MEETING NOTES

Meeting Date: Thursday, July 21, 2016 – 1:00pm – 2:30pm
 DFD Project Number: 14I2O
 Project: Wittich Hall Renovation
 Location: 153 Murphy, UW-La Crosse
 Purpose: Executive Committee Summary Meeting

EXECUTIVE COMMITTEE SUMMARY – 7/21

WITTICH HALL

MEETING SUMMARY – EX COMM PLAN REVIEW

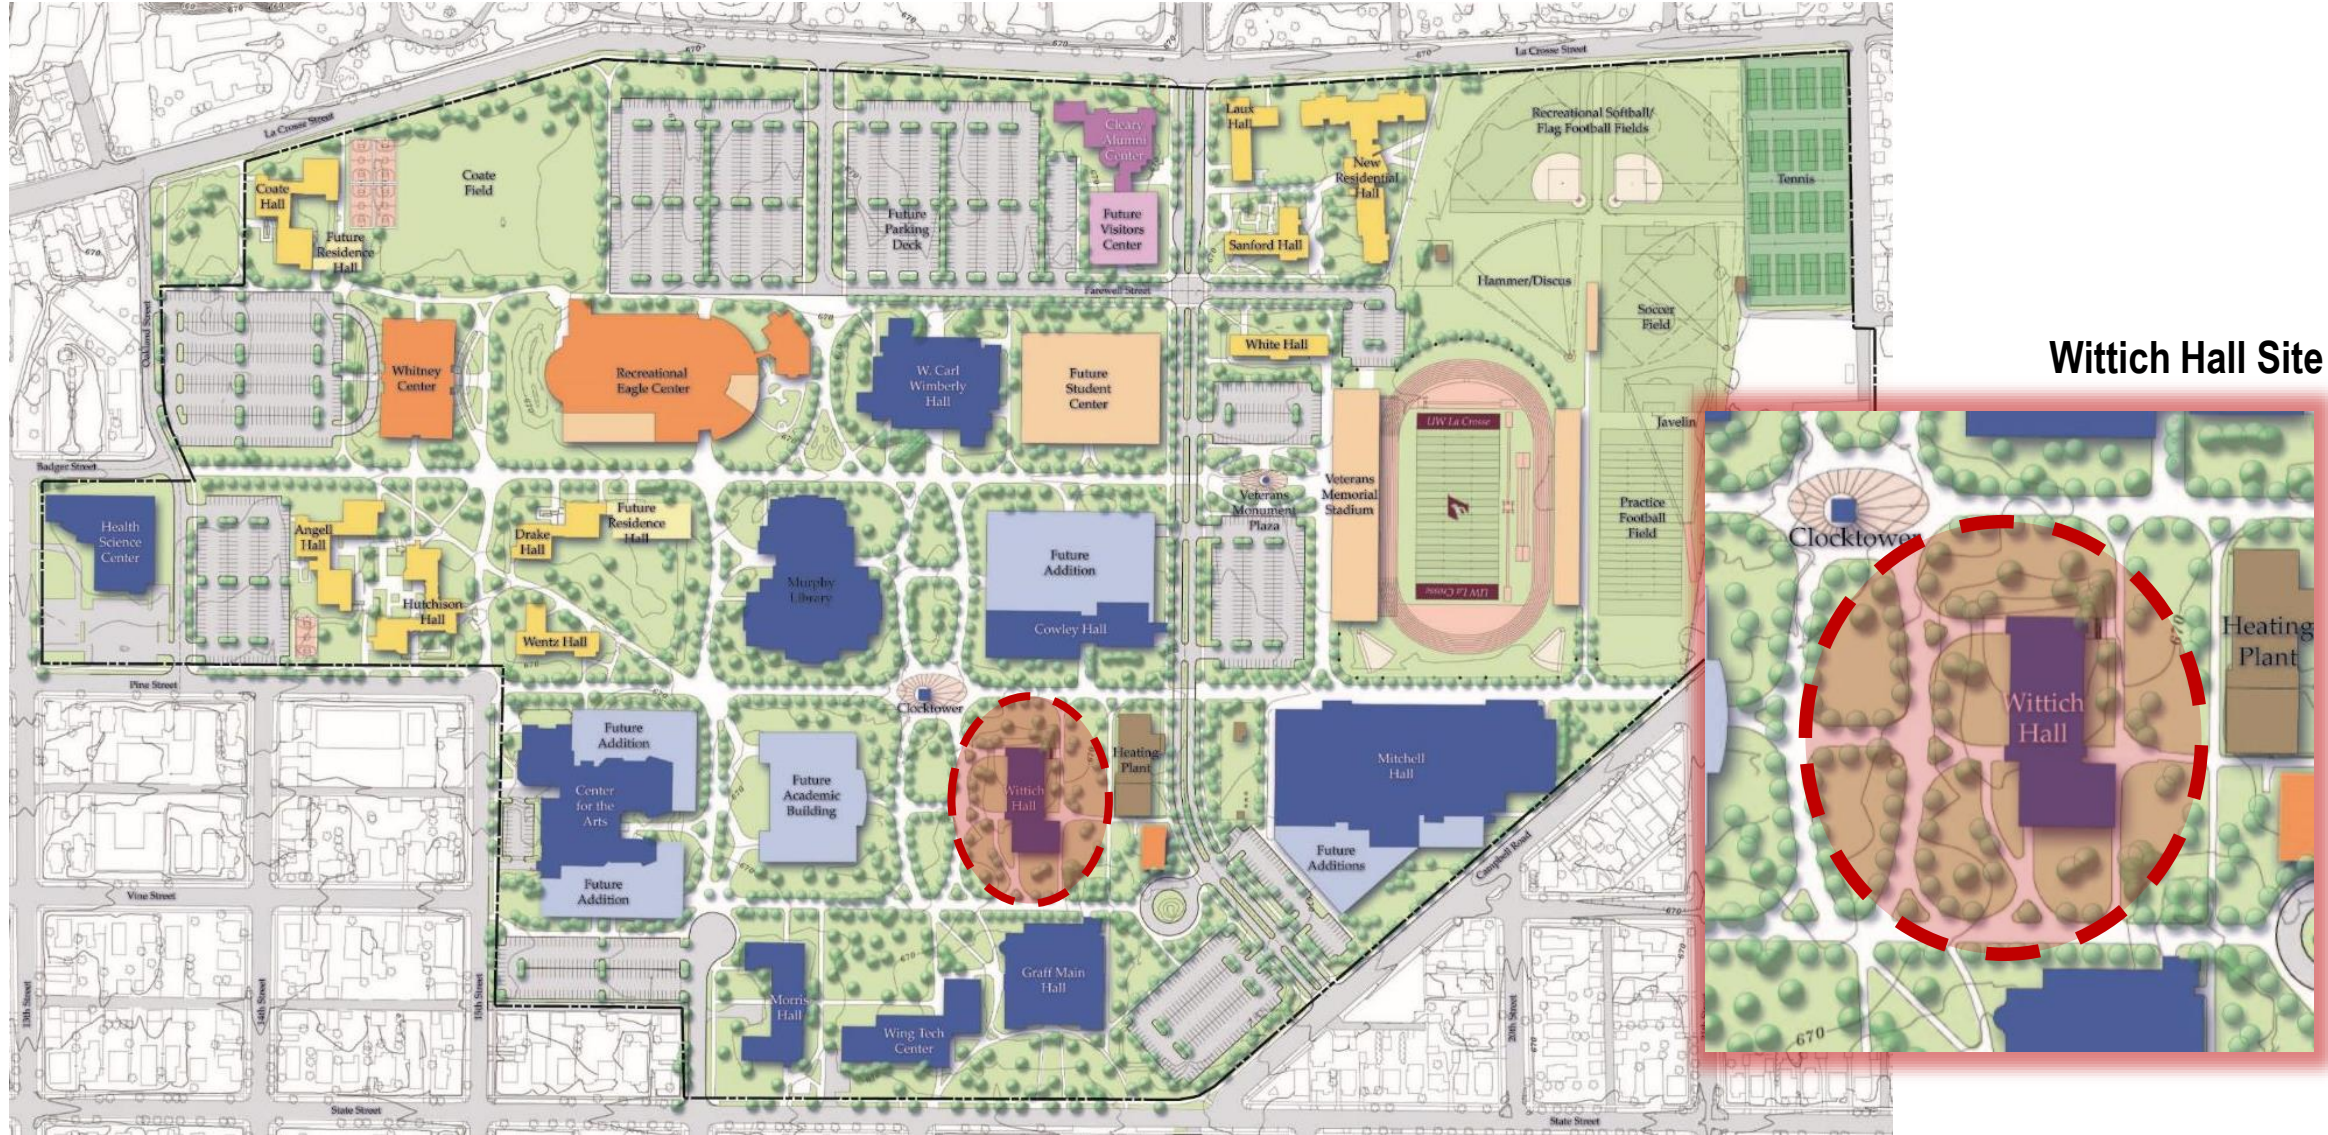
- 24 person meeting room in question
 - Aro Eberle / Paulien to collect utilization data
 - If not a 24 person meeting room – then what is space use?
- Asked to fit Accountancy, Finance & Economics together on a floor
- CBA to discuss potential Programming for the Lower Level shelled space
- Other potential bonus space on the 2nd floor
 - Missing IT / Electrical closets to be added to plans
- Adjunct space concepts to be developed
- Make revisions to the Dean's Office per comments
- Room data sheet package with floor plan to be distributed to Departments to fill out / review

Site Utilities & Stormwater

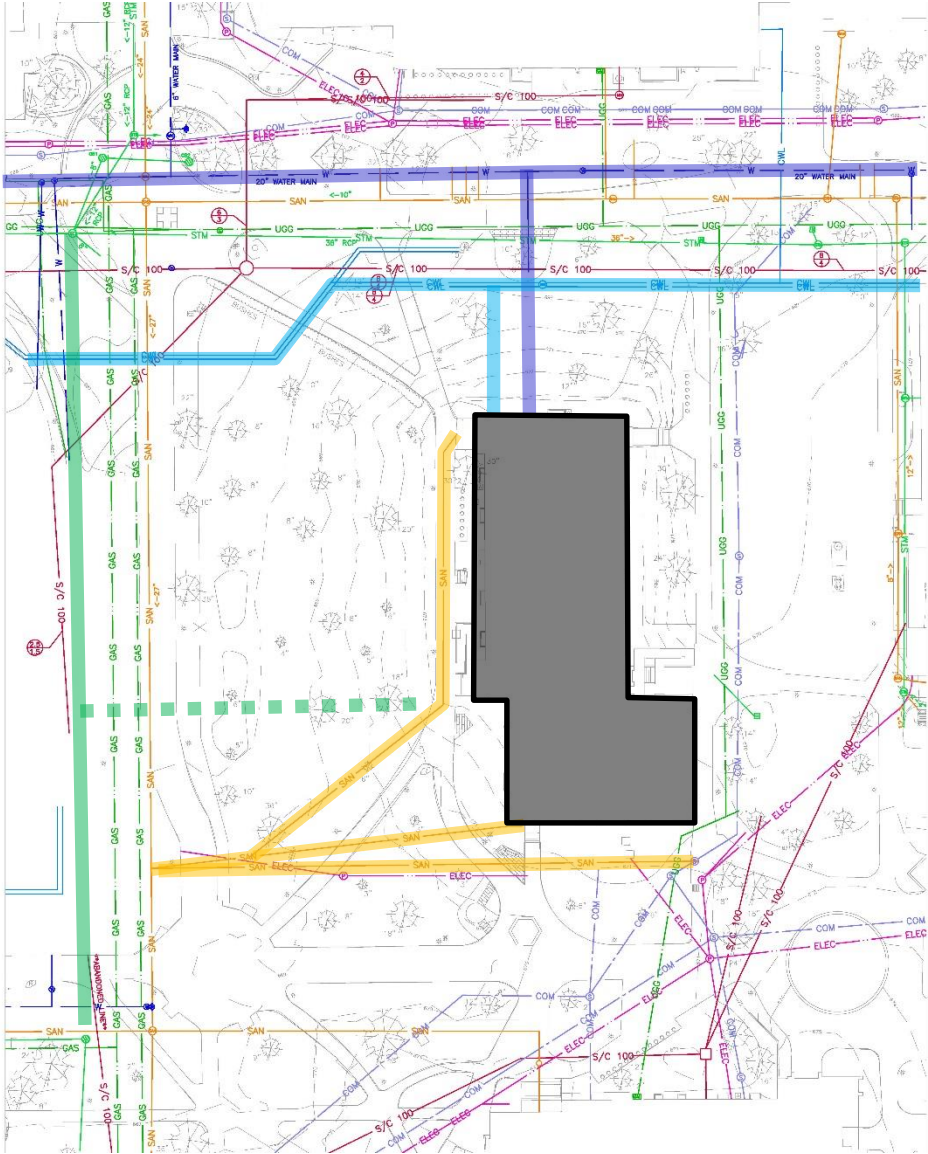
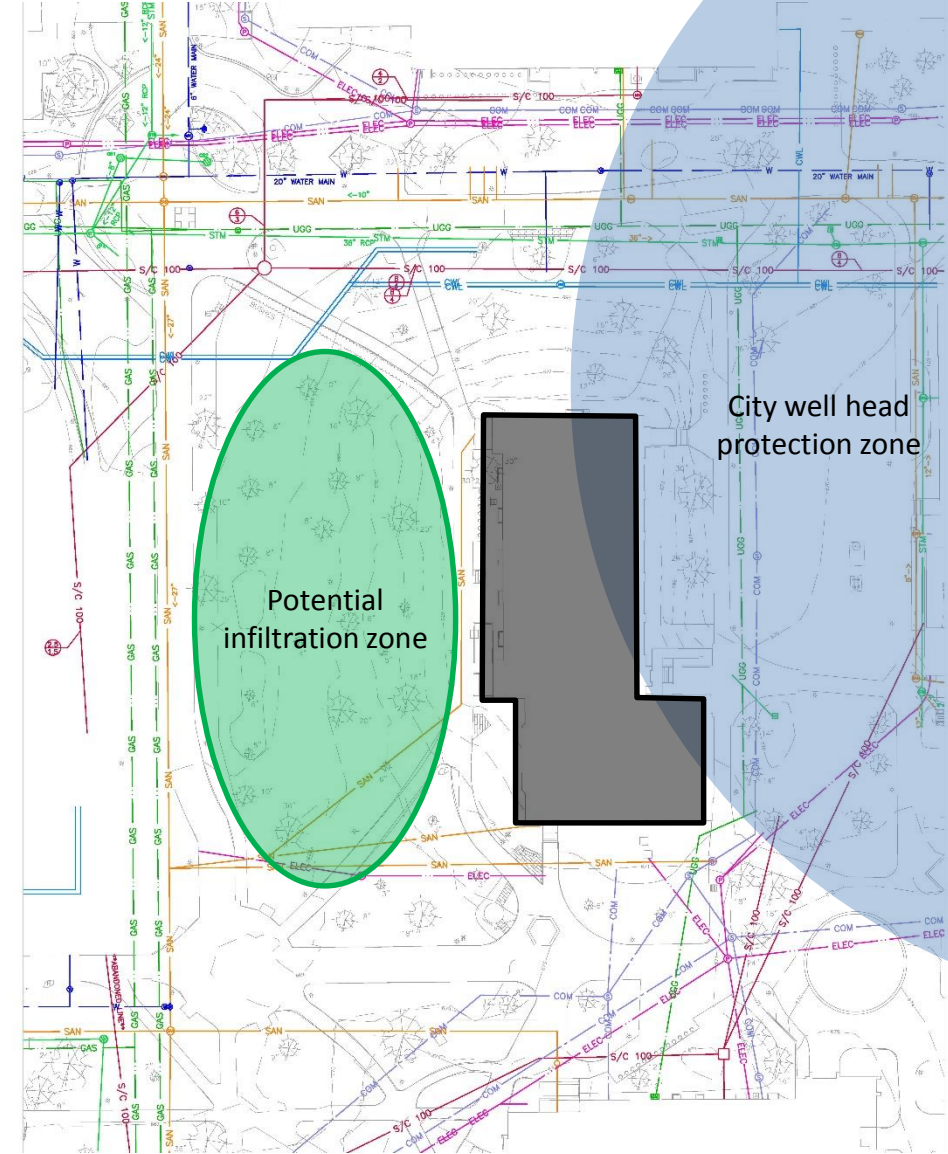
- Water Main Original – Replace and add redundant feed.
- New Chilled water
- Sanitary and storm to be separated. Sanitary replaced
- Storm – explore rain gardens

Then & Now - Exterior

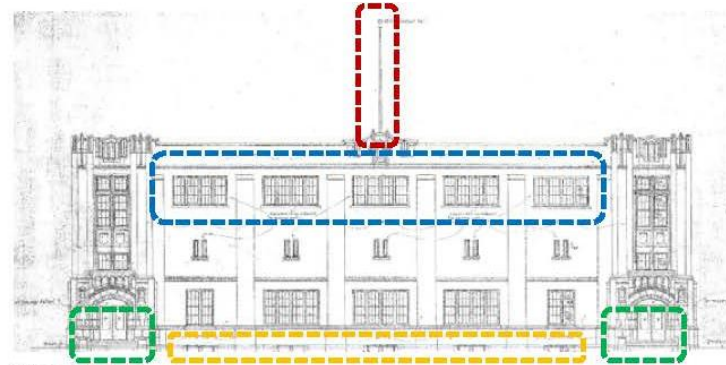
- Track level windows have been replaced with glass block.
- Entrance doors have been replaced with aluminum storefront systems.
- Spire has been removed.
- Entrance stairs have been replaced.
- Seat walls have been removed.
- Wood screens appear to be intact.
- Wood windows at lower floors and stairs appear to be original.
- Lower level (sub-grade) windows have been replaced with glass block

FACILITY CONDITION ASSESSMENT – FLOOR FLATNESS

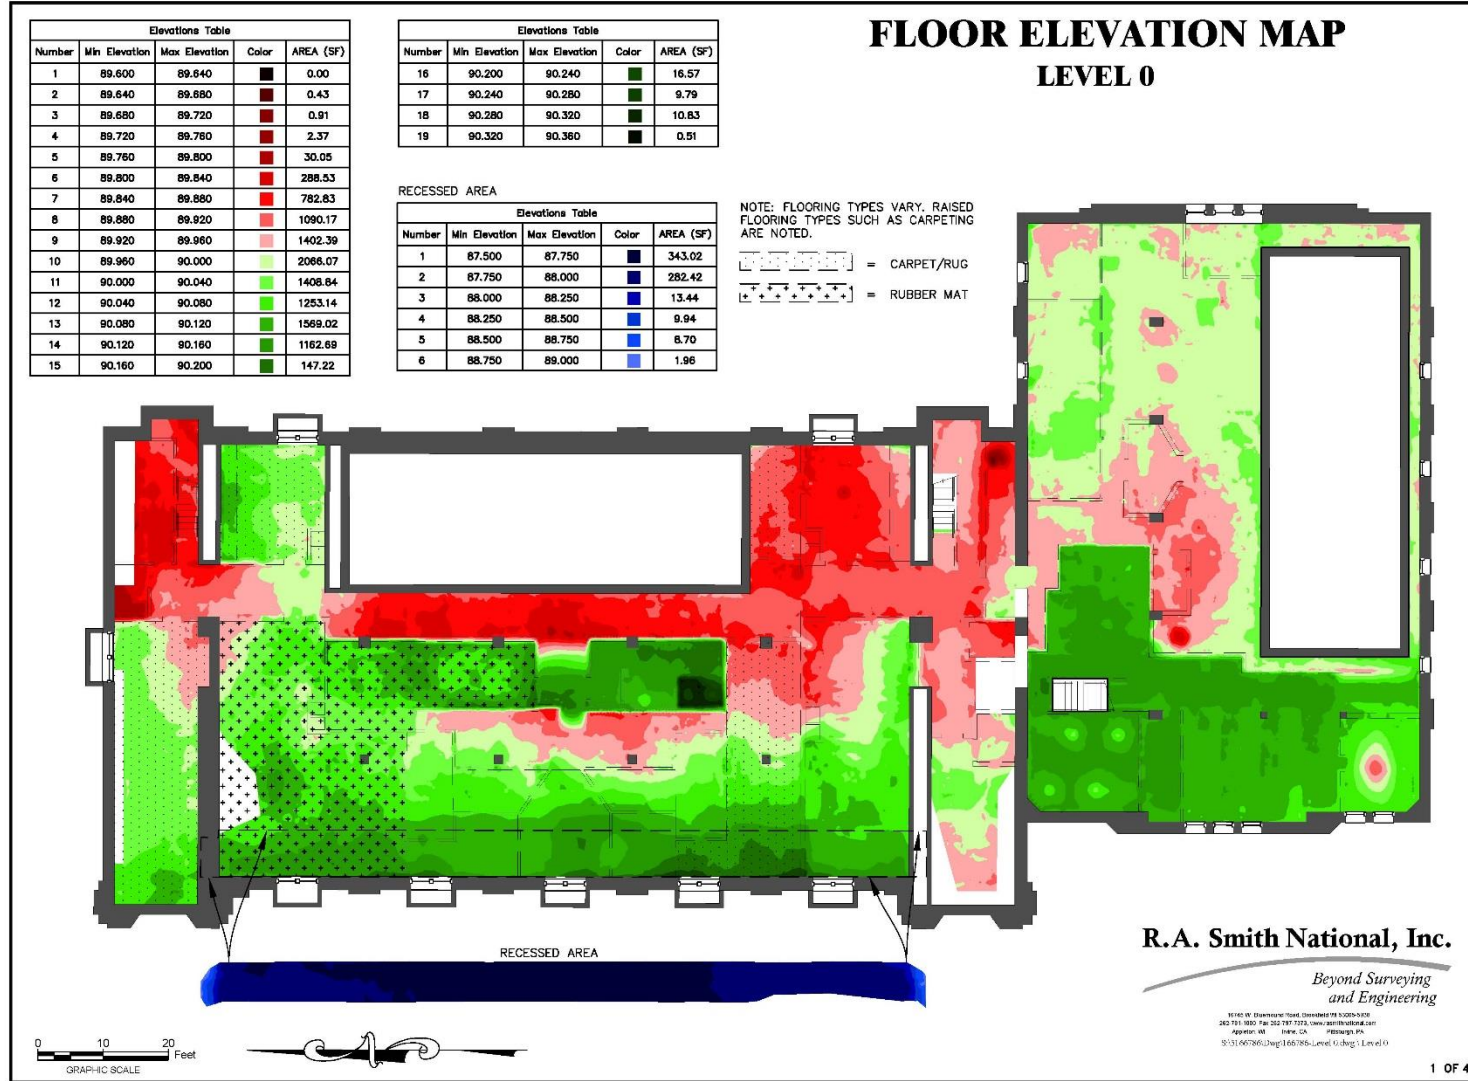
- Laser scans revealed level changes of 4" in a span of 40 feet in some locations of the Lower Level
- Some variation is due to existing floor finishes, rubber flooring in some spaces
- Depending on final floor finishes selected, leveling will need to be done to bring the building up to current standards. Portions of slab will be removed for underslab piping replacement.
